Pendleton Office

Addendum #3

Pendleton Office
Addendum No. 3
Date: August 13, 2025

Date: 08/12/25
Client: SRA
Project: Pendleton Park
Hemphill, Texas
Project No.: 21.095

A2 RR 119 & 121 ENLARGED
A104 SCALE: 1/2" = 1'-0"

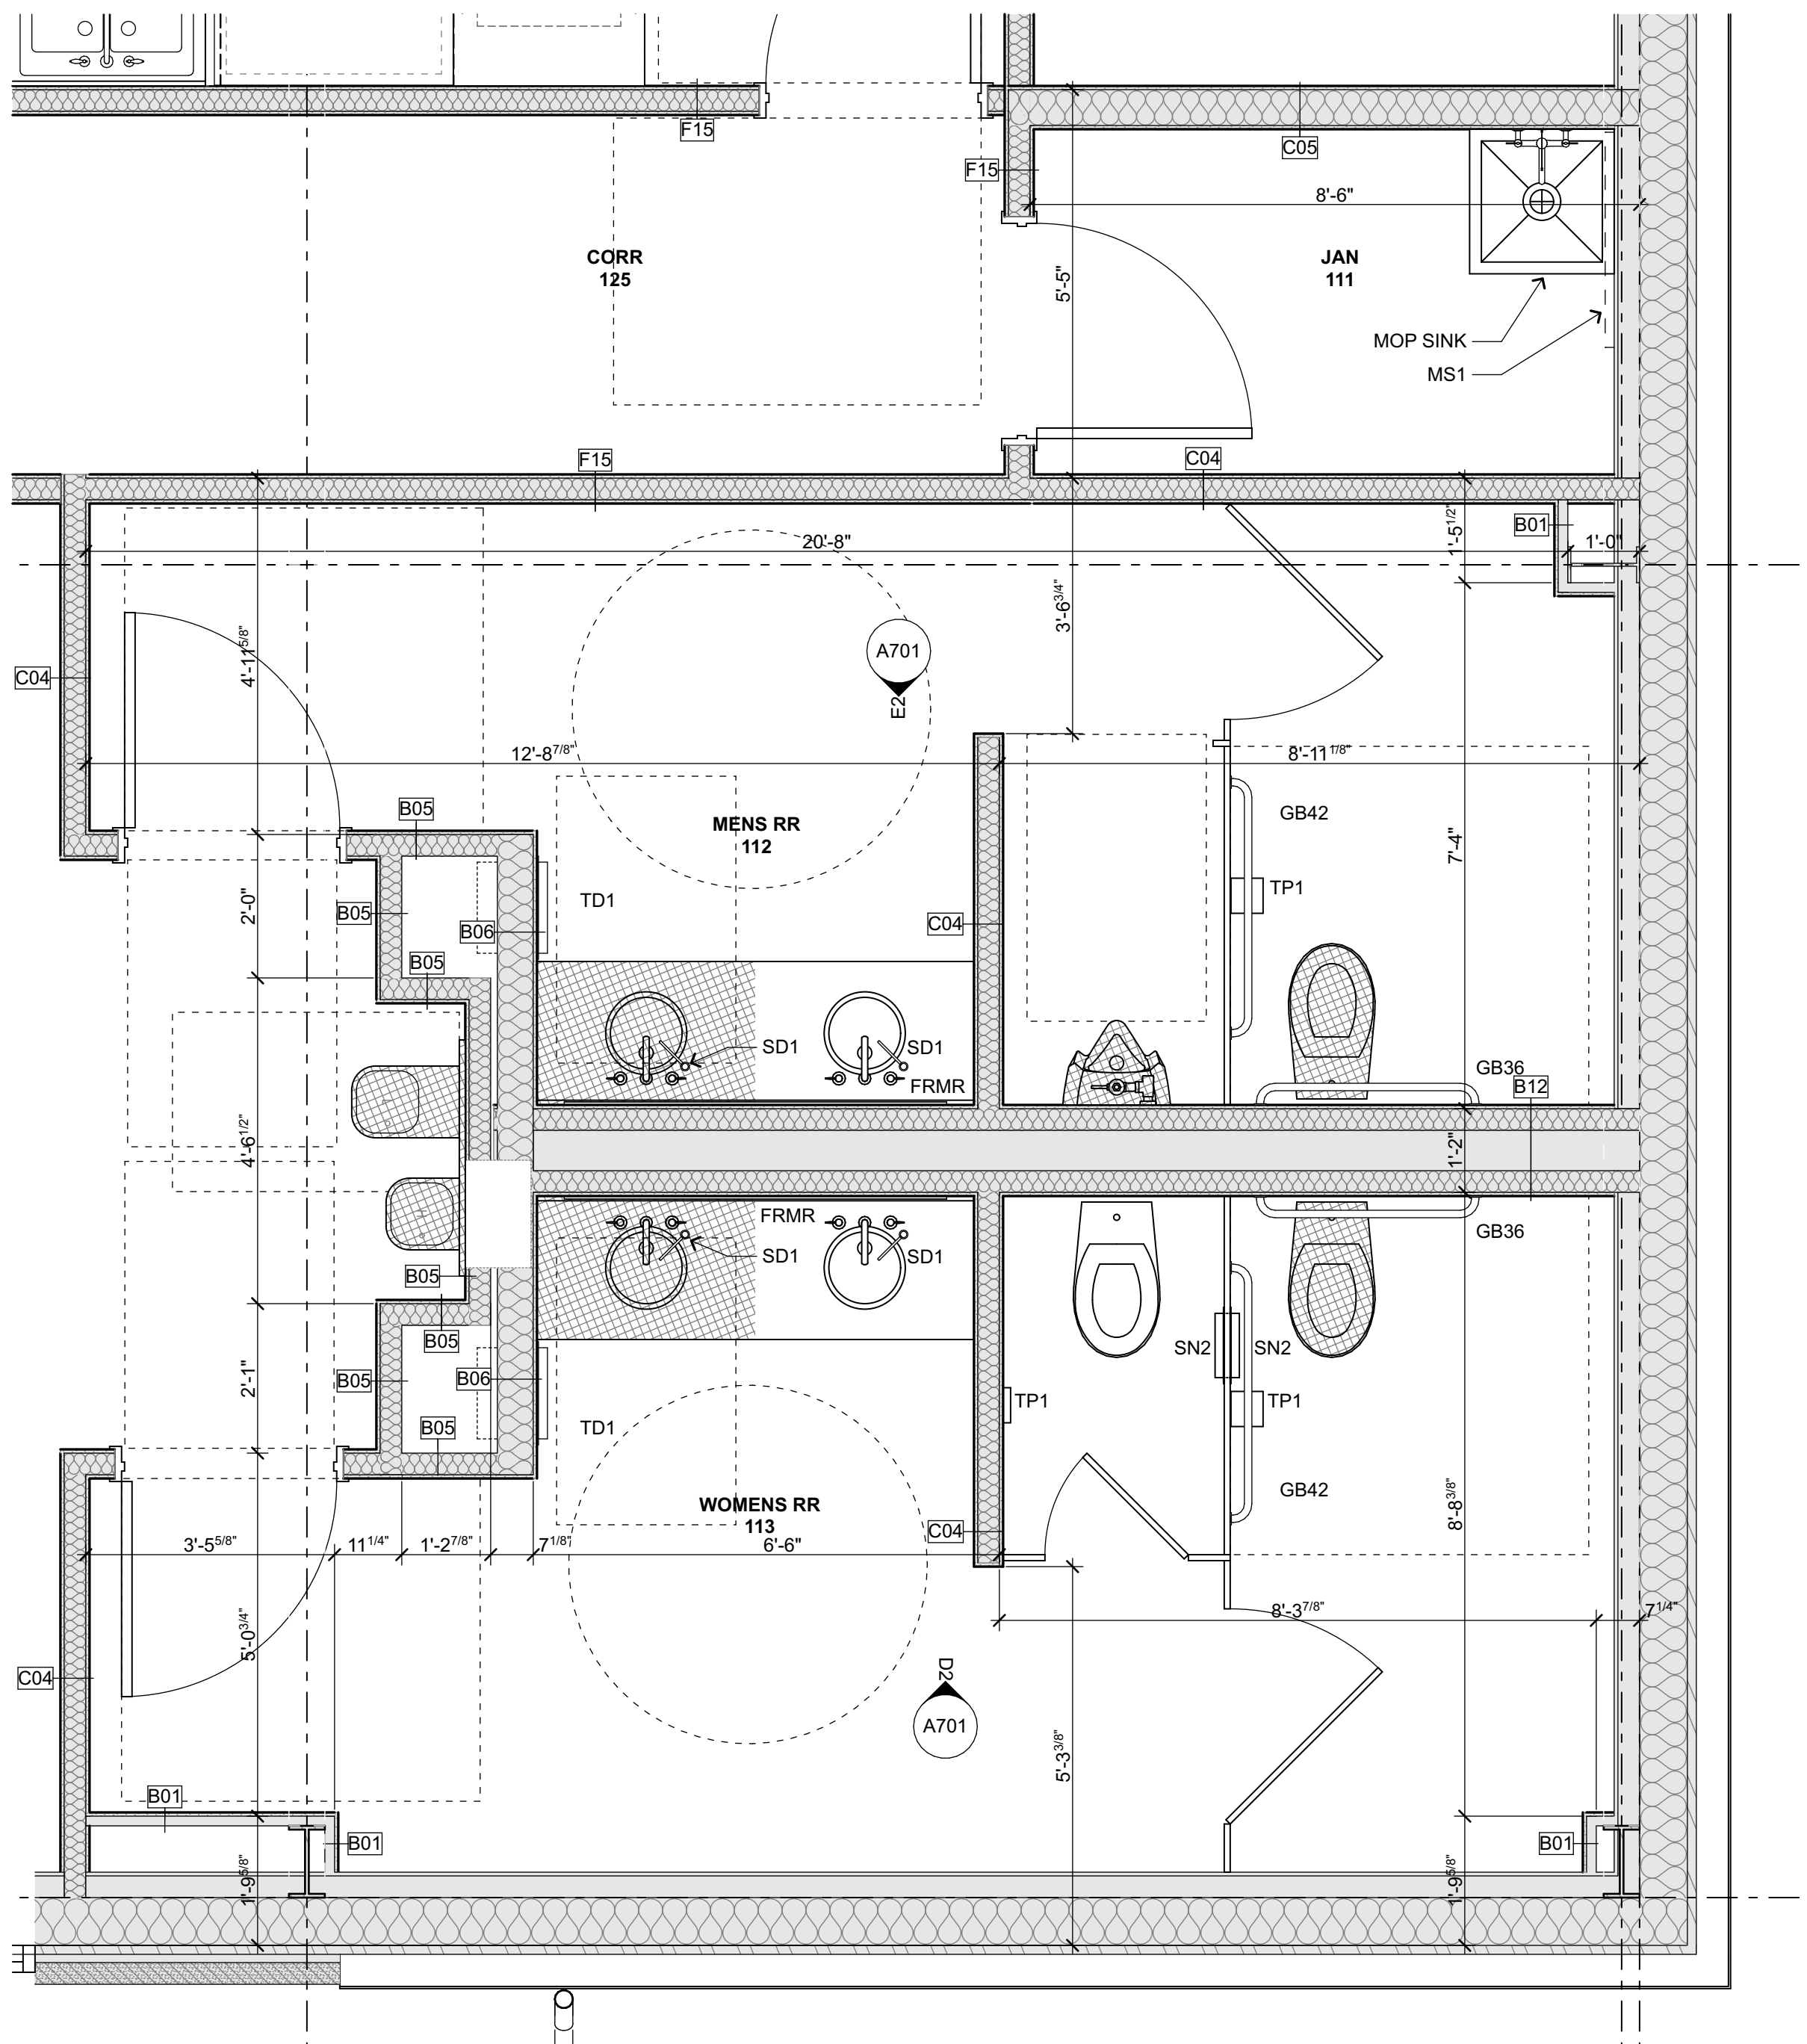
- ITEM 1.01. A104 – REVISION Interior elevation markers added to restrooms.
- ITEM 1.02. A201 – REVISION Restroom wall tile style designation changed. Restroom 118 and Restroom 119 all walls to be tiled.
- ITEM 1.03. A701 – REVISION Interior elevations added.

FLOOR PLAN - POWER

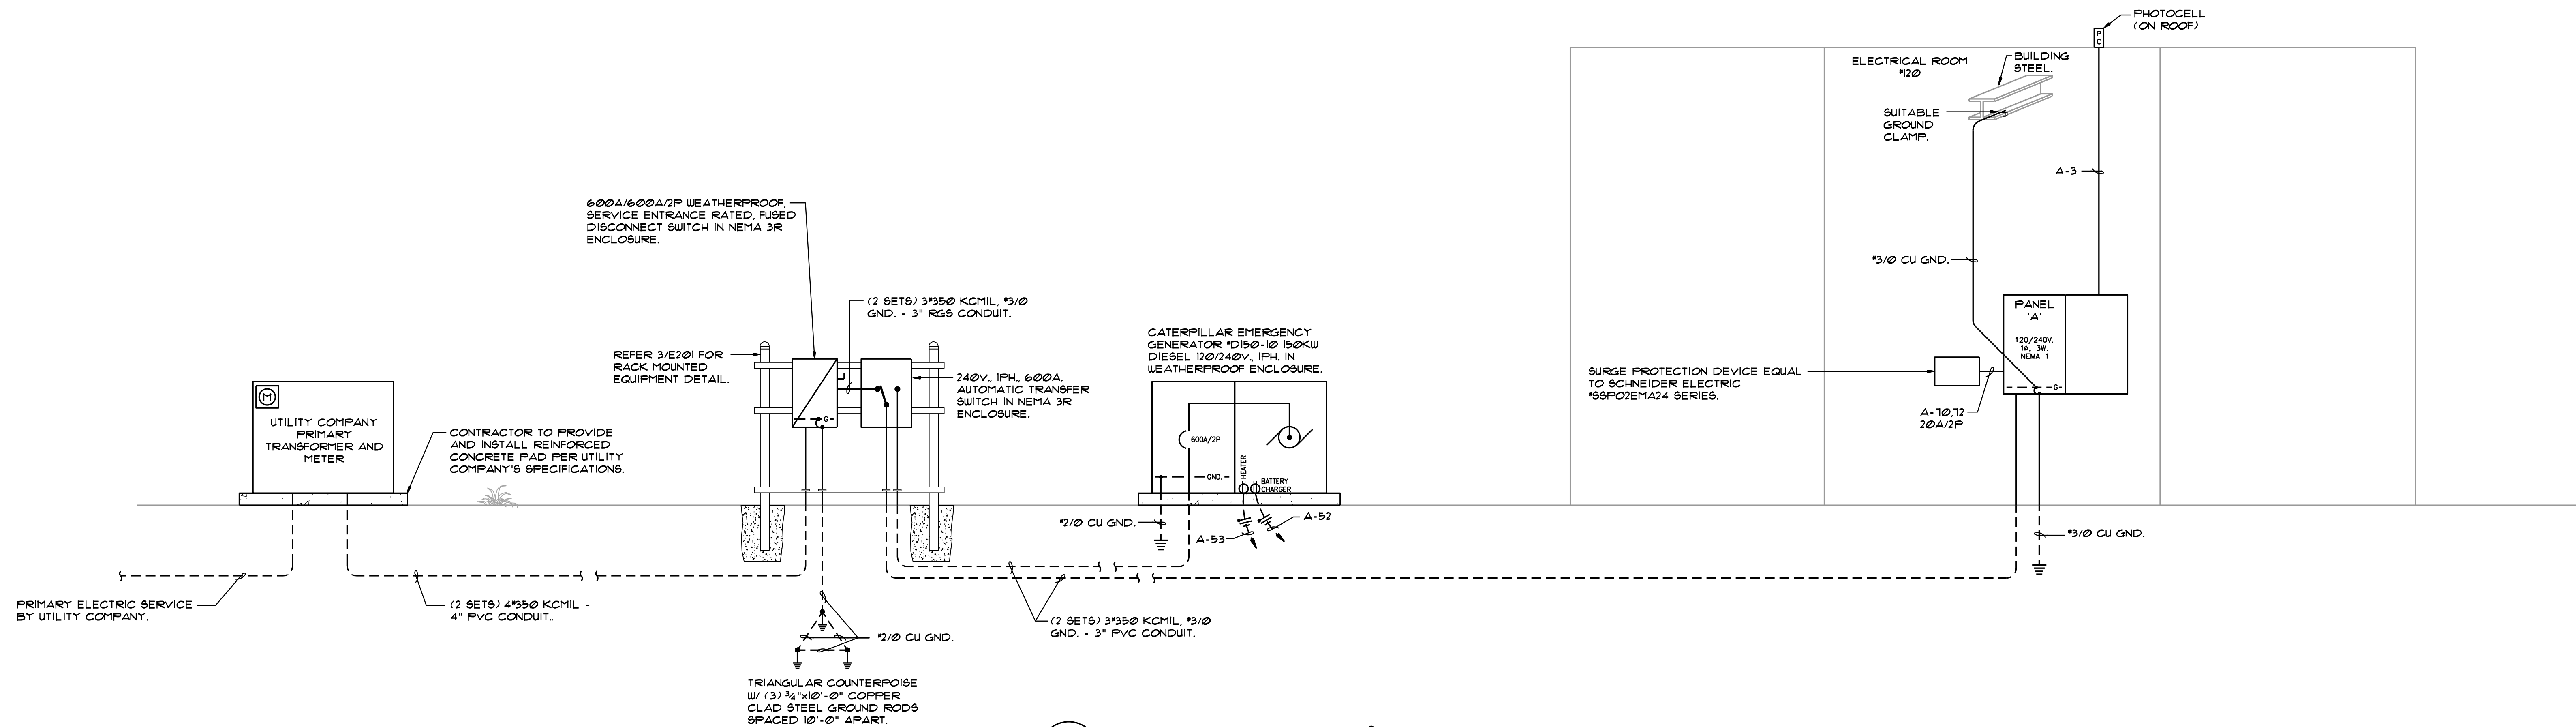
- ITEM 1.04. E102 – REVISION Conduit for video display to above accessible ceiling.
- ITEM 1.05. E102 – ADDITION Add additional receptacles and branch circuits for “stacked” microwaves at Kitchen and Break Rm.
- ITEM 1.06. E102 – ADDITION Add 4” conduit between IT Room and Storage Rm. 108.
- ITEM 1.07. E102 – ADDITION Add (2) duplex receptacles and branch circuits for A/V rack equipment.
- ITEM 1.08. E102 – ADDITION Add (3) 2” conduits from A/V Rack to above ceiling.
- ITEM 1.09. E102 – ADDITION Add (2) floor boxes for Data/Com and conduit to Storage Rm. 108.
- ITEM 1.10. E102 – ADDITION Add (1) additional floor box with duplex receptacle and data outlet.
- ITEM 1.11. E102 – ADDITION Add (3) junction boxes and conduit for Cameras to above accessible ceiling.
- ITEM 1.12. E200 – ADDITION Added new branch circuits to Panel ‘A’ schedule.
